Access Compliance Report

Public Rights-of-Way

(Curb Ramps)

Intersection ID: 9091	Main Street: GRANT_ST	Cross Street: MARIETTA_ST	Location: S
ADA ID: 69642593E3FC	Ramp Type: Perp	Initial Pass/Fail: Fail	Overall Compliance: No
Severity Score: 10			
Codes/Mitigation Info/Possible Solution		Field Measurements/Component Compliance

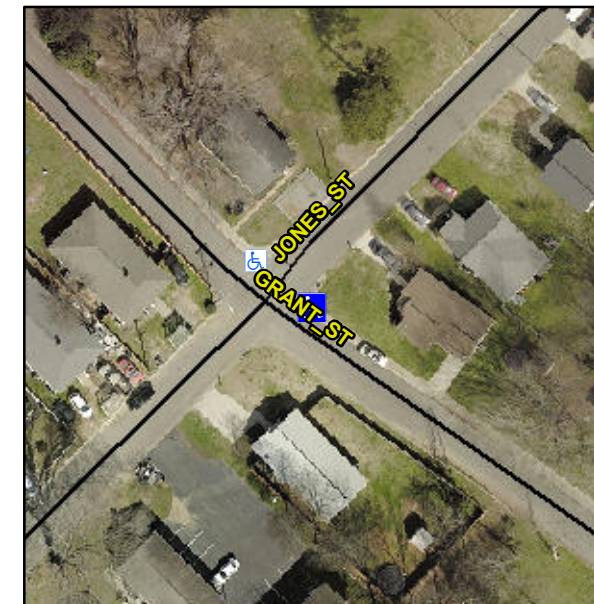
Not Found, R304.5.1, R304.5.3

Compliance	Description	Data	Compliance	Description	Data
N/A	Ramp Length (in)	41.5	Yes	Ramp Slope (%)	6.1
No	Ramp Width (in)	47.0	No	Ramp XSlope (%)	2.1
N/A	Flare Type LT	N/A	N/A	Flare Type RT	N/A
N/A	Flare Slope LT (%)	N/A	N/A	Flare Slope RT (%)	N/A
N/A	Flare Traversable LT?	N/A	N/A	Flare Traversable RT?	N/A
N/A	Landing Length (in)	N/A	N/A	DWS Provided?	N/A
N/A	Landing Width (in)	N/A	N/A	DWS Contrast?	N/A
N/A	Landing Slope (%)	N/A	N/A	DWS Length (in)	N/A
N/A	Landing X Slope (%)	N/A	N/A	DWS Full Width?	N/A
N/A	Landing Curb? (Y/N)	N/A	N/A	DWS Offset (in)	N/A
N/A	Shared Landing?	N/A			
N/A	Gutter Ponding?	N/A	N/A	Gutter Slope (%)	N/A
N/A	Gutter Lip Ht (in)	N/A	N/A	Gutter X Slope (%)	N/A
N/A	Painted X Walk1?	No	N/A	Painted X Walk2?	N/A
	X Walk 1 Direction	To NW		X Walk 2 Direction	N/A
N/A	X Walk 1 Width (in)	N/A	N/A	X Walk 2 Width (in)	N/A
	X Walk 1 Slope (%)	2.8		X Walk 2 Slope (%)	N/A
	X Walk 1 X Slope (%)	0.3		X Walk 2 X Slope (%)	N/A

Remove & Replace Entire Ramp.
